RE: **Response to Peer Review Comments**
The Village at Sudbury Station – 30 Hudson Road Sudbury, Massachusetts

MDM Transportation Consultants, Inc. (MDM) has prepared the following response to transportation-related peer review comments for the above-referenced project, as issued in a letter by the City's peer review consultant, Vanasse and Associates, Inc. (VAI), dated March 3, 2016. To facilitate review, specific comments are paraphrased with corresponding responses. Where appropriate, responses provided with input from the Applicant's design team are noted and include Sullivan Connors Associates (SCA) and Winn Residential (Winn).

Exhibit 5
AutoTurn Analysis
Sudbury Ladder Truck

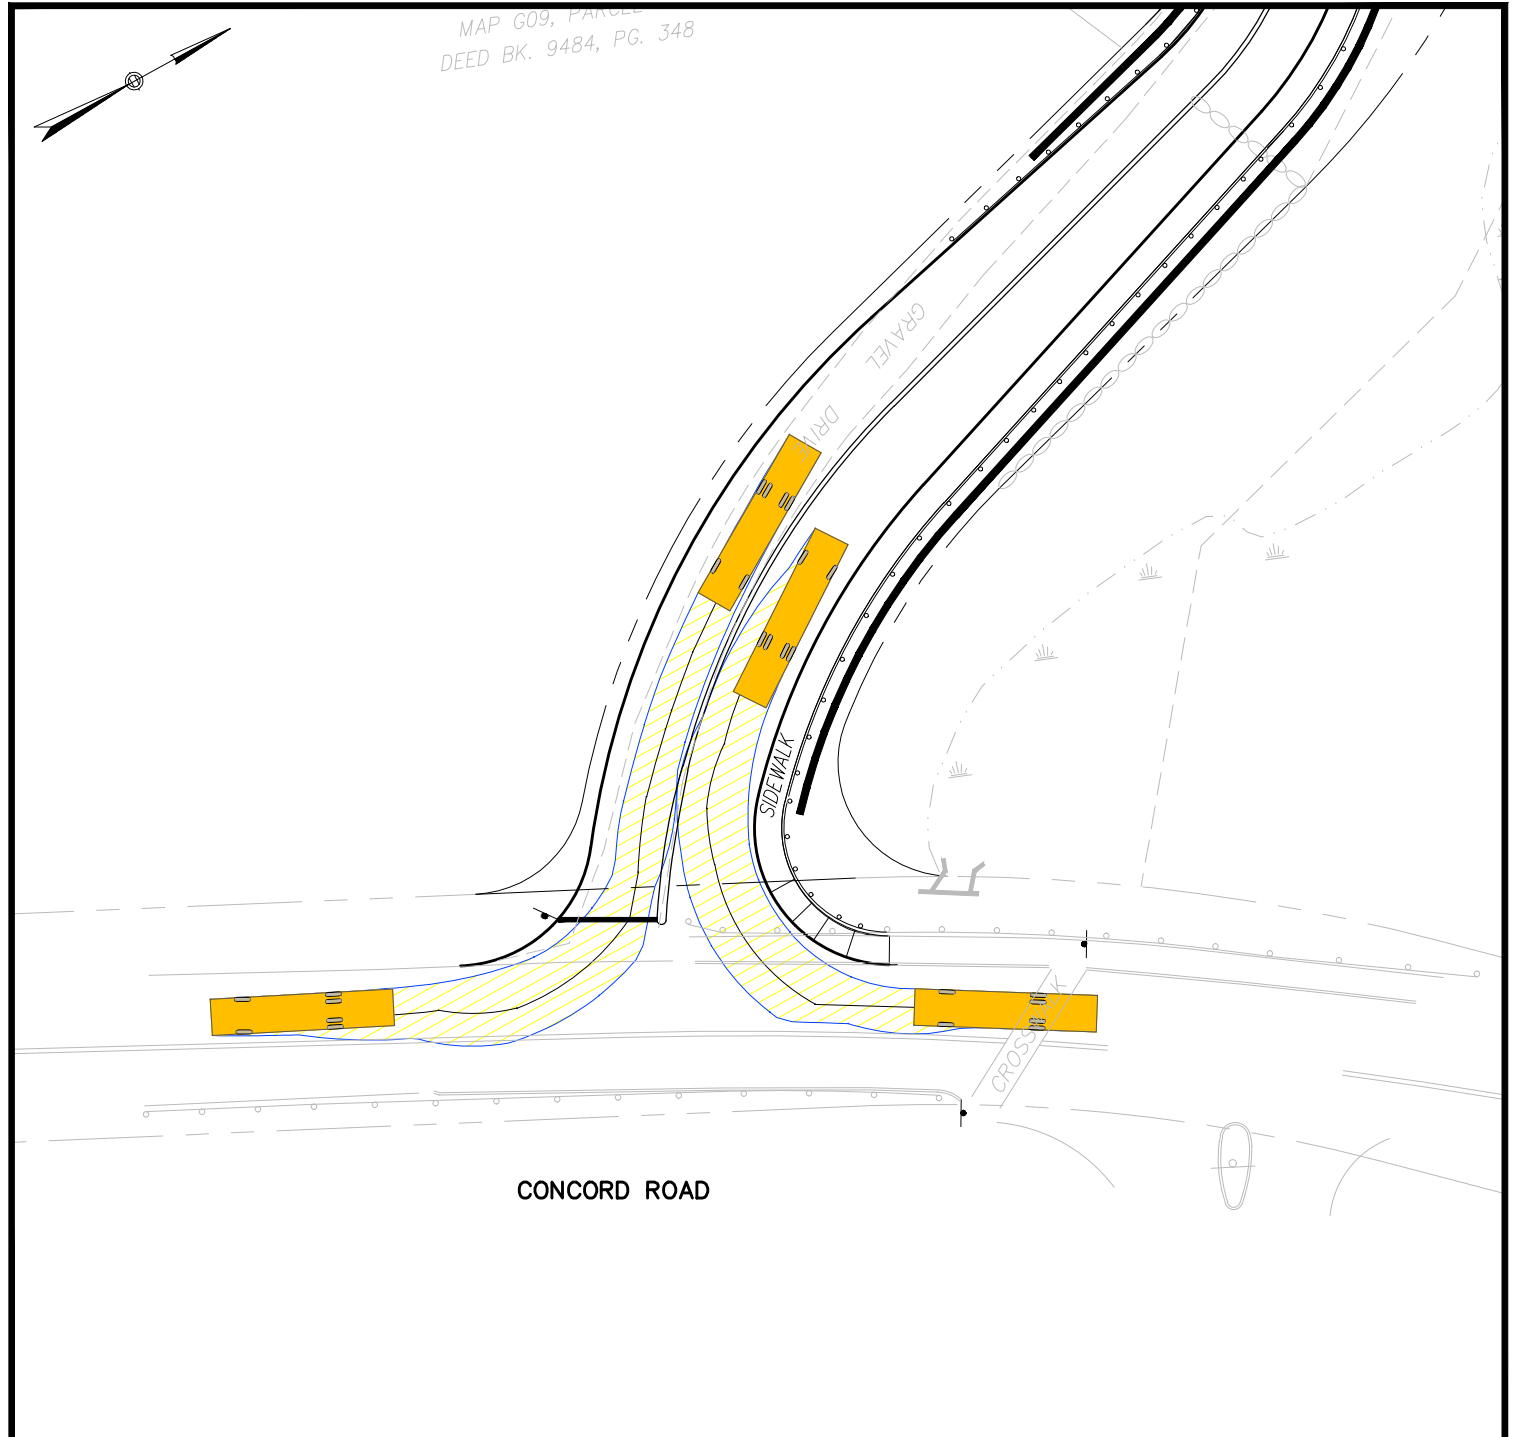
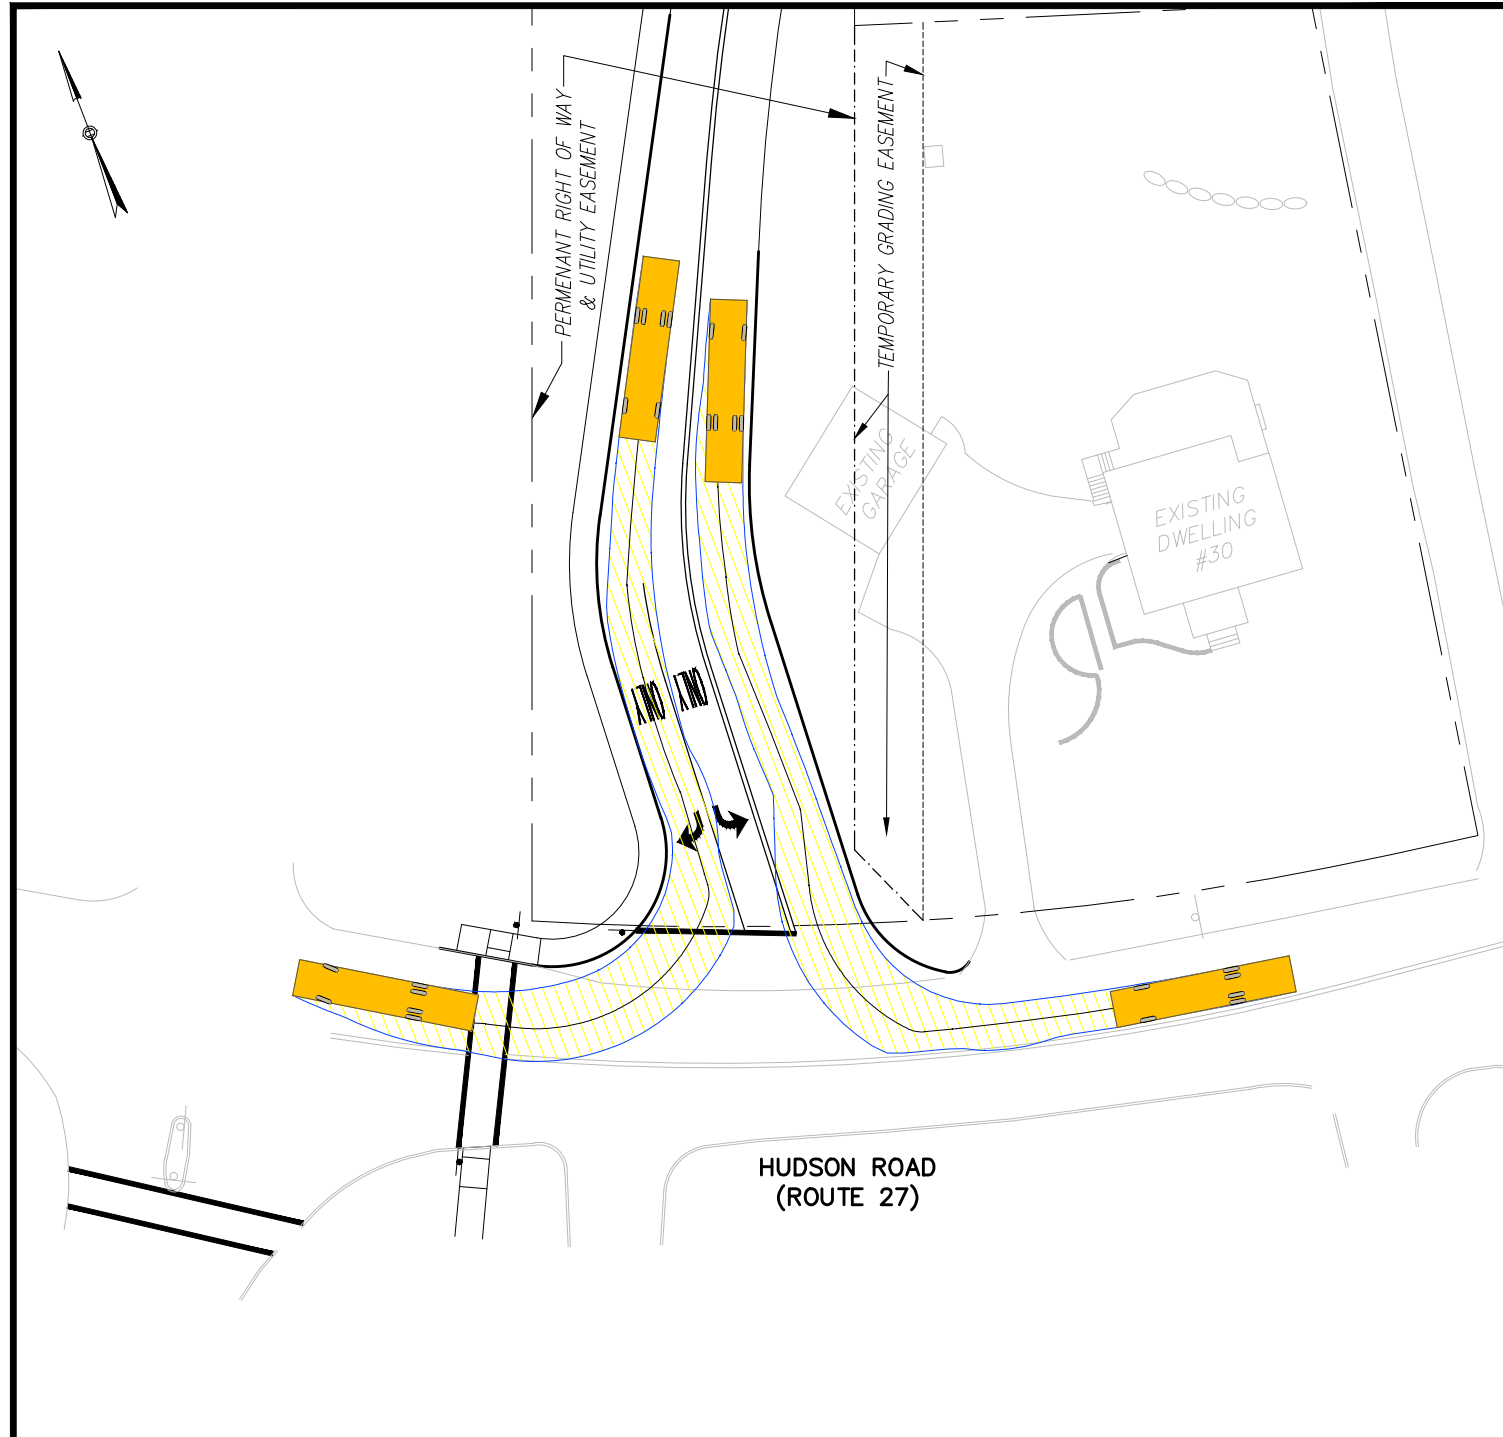
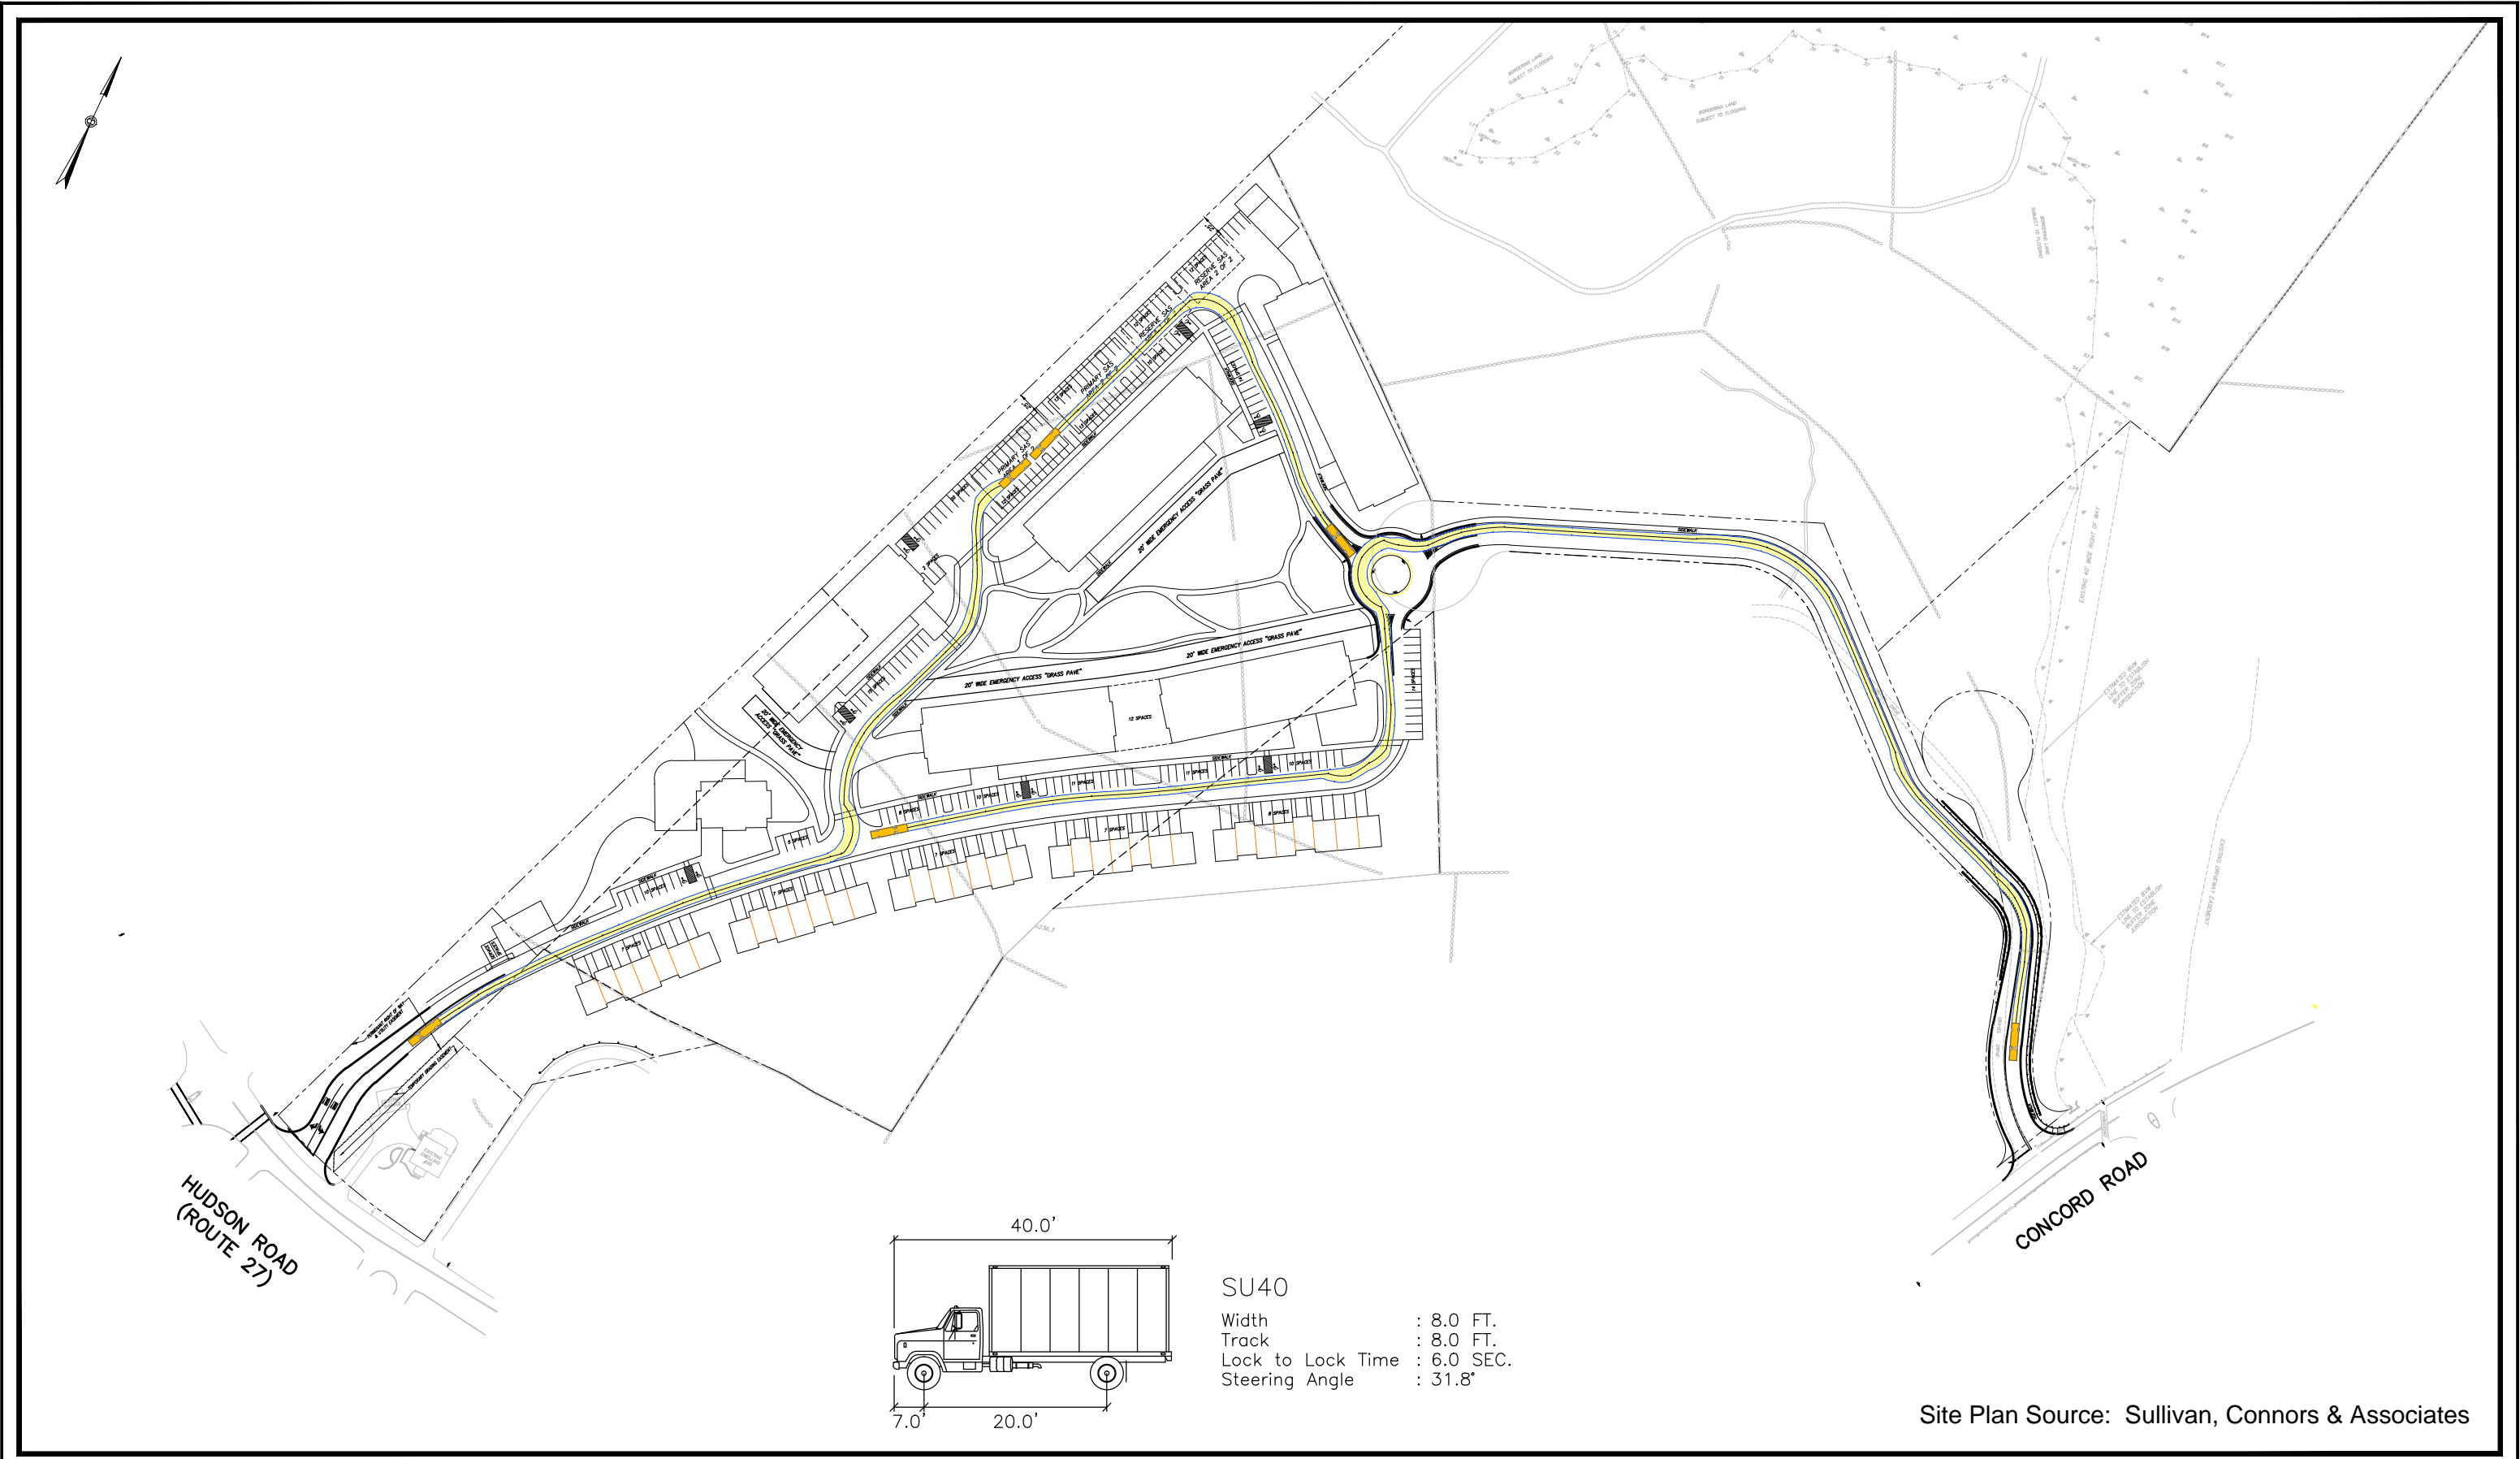
Comment T11: *"A truck turning analysis should be completed for the Project using the following design parameters as guidance: i) the analysis should be completed using the AutoTurn® or similar analysis software for the following design vehicles: an SU-30/40 (small delivery/moving vehicle and trash/recycling vehicle) and the Town of Sudbury Fire Department design vehicle; ii) the analysis should include the swept path for the front and rear tires of the design vehicles and any overhangs that may extend past the front and rear bumper of the vehicle (i.e., basket of the aerial ladder of the fire truck if so equipped); iii) the analysis should depict all maneuvers required to enter and exit the Project site by way of Route 27 and Concord Road (both left and right-turn movements entering and exiting), and all turning and maneuvering required within the Project site; iv) Back-up maneuvers, where required, should be clearly identified."*

Response: Requested AutoTurn® vehicle turn analysis has been conducted for the updated Site Plan of March 14, 2016 for a box truck (SU-40 design vehicle) and the Town's fire ladder truck. Resulting swept paths are depicted on **Exhibit 4** (Sudbury Ladder Truck at Site Driveways), **Exhibit 5** (Sudbury Ladder Truck within the Site), **Exhibit 6** (SU-40 Truck at Site Driveways) and **Exhibit 7** (SU-40 Truck within the Site). These exhibits show that ample roadway with and intersection geometry is provided to accommodate the swept path of these vehicle types.

DETAIL FOR RAISED CROSSWALK
PAVEMENT MARKINGS
NOT TO SCALE

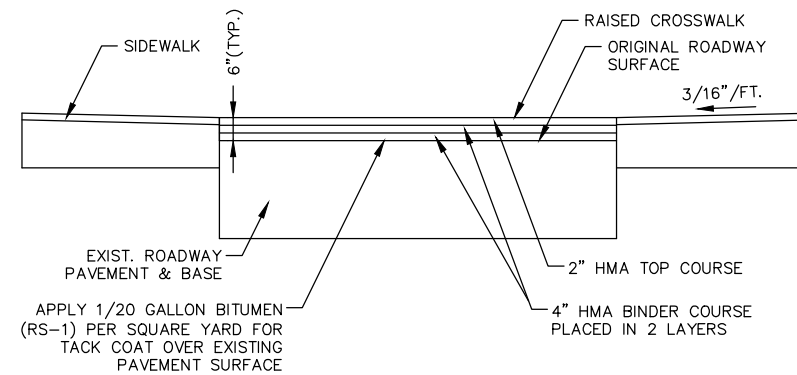
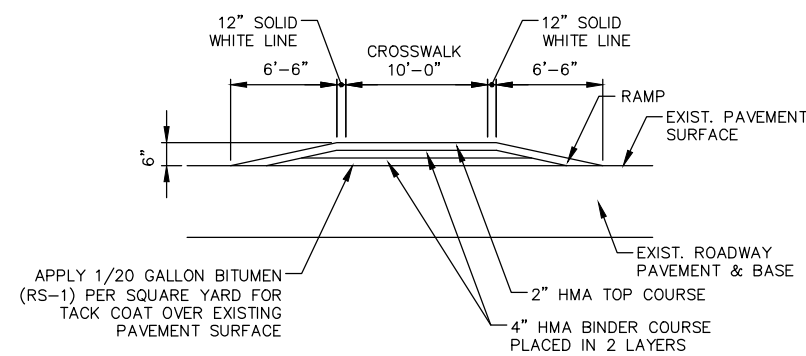
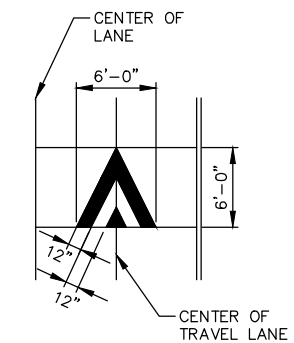
Comment T17: *"Given the length of the access roadway and the potential for increased travel speeds, raised crosswalks with accompanying warning signs should be used within the Project where crossings are proposed, excepting those located at an intersection."*

Response: The Applicant is consulting with the Fire Department to solicit their input on the suitability and placement of raised pedestrian crossings; these design features will be implemented by the Applicant with appropriate MUTCD-compliant signs once specific crossing locations are identified. **Exhibit 8** provides a typical detail for a raised crosswalk that will be incorporated into the Site Plans once concurrence is obtained from appropriate Town departments; associated MUTCD-compliant warning signs will also be added once these design features are deemed appropriate and acceptable.
